**FIELD REPORT – CARILLON POINT BUILDING 4000 – FIELD REPORT**

**Report Number: 9**

**Project No.** 10-030608K1

4000 Carillon Point  
Kirkland, Washington

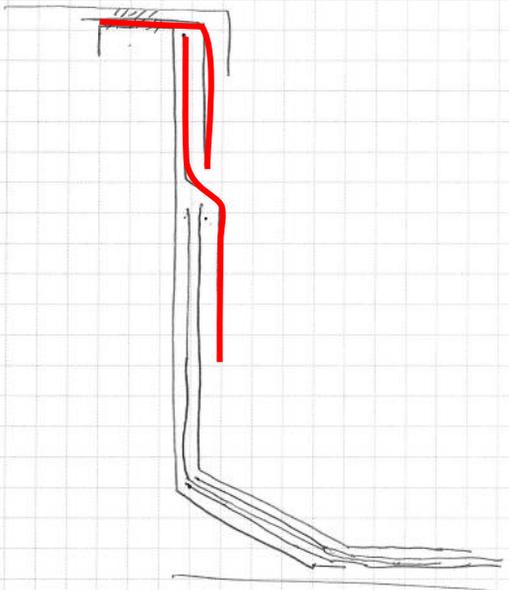
- 1.9 Low Skylight: The large, older, skylight at the west side of the penthouse has sheet metal counterflashing that extends under the skylight frame preventing the new roof membrane from extending minimum 8 inches vertically. As discussed, cut the existing skylight approximately halfway up the width to allow the roof membrane to extend vertically 8 inches. New sheet metal flashing to be inserted up under the existing flashing and riveted to existing flashing.

Update Rep #5, 6/20/16: The new roof membrane was tucked under the existing flashing and appears to be extended 8 inches off the finished roof surface. It appears the existing metal can be left and new skirt flashing metal installed under the existing metal, without cutting the existing metal.
